Project	IEEE 802.16 Broadband Wireless Access Working Group http://ieee802.org/16 Clarification of renumbering and permutation based on DL_PermBase parameter 2005-05-05	
Title		
Date Submitted		
Source(s)	Sean Cai Jason Hou Liujun Hu	scai@ztesandiego.com jhou@ztesandiego.com
	ZTE San Diego Inc. 10105 Pacific Heights Blvd. San Diego, CA 92121 USA	Voice: 858-554-0387 Fax: 858-554-0894
	Lei Wang	lwang@cygnuscom.com
	Cygnus Multimedia Communications, Inc.	Voice (760)448-1984 Fax: (760)448-1989
	Yigal Leiba Yossi Segal Runcom Ltd.	yigall@runcom.co.il Voice:+972-3-9528440 Fax:+972-3-9528805
Re:	IEEE 802.16 WG Recirculation Ballot #17a on P802.16-2004/Cor1/D2	
Abstract	This contribution is for clarification of renumbering and permutation based on DL_PermBase parameter	
Purpose	To incorporate the text modification proposed in this contribution into P802.16-2004/Cor1/D3.	
Notice	This document has been prepared to assist IEEE 802.16. It is offered as a basis for discussion and is not binding on the contributing individual(s) or organization(s). The material in this document is subject to change in form and content after further study. The contributor(s) reserve(s) the right to add, amend or

Figure 219-Illustration of OFDMA frame with multiple zones

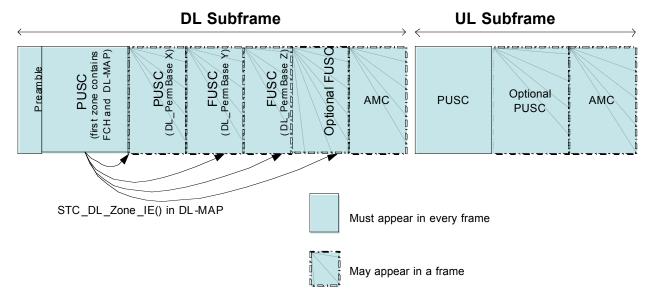
In the DL-MAP, a BS may transmit DIUC = 15 with the TDSTC_DL_ZONE_IE() to indicate that the subsequent allocations shall use a specific permutation, or be transmit diversitySTC encoded. The downlink frame shall start in PUSC mode with <a href="https://example.com/link-nc/market-nc/mark

[Replace Figure 219 with the following figure:]
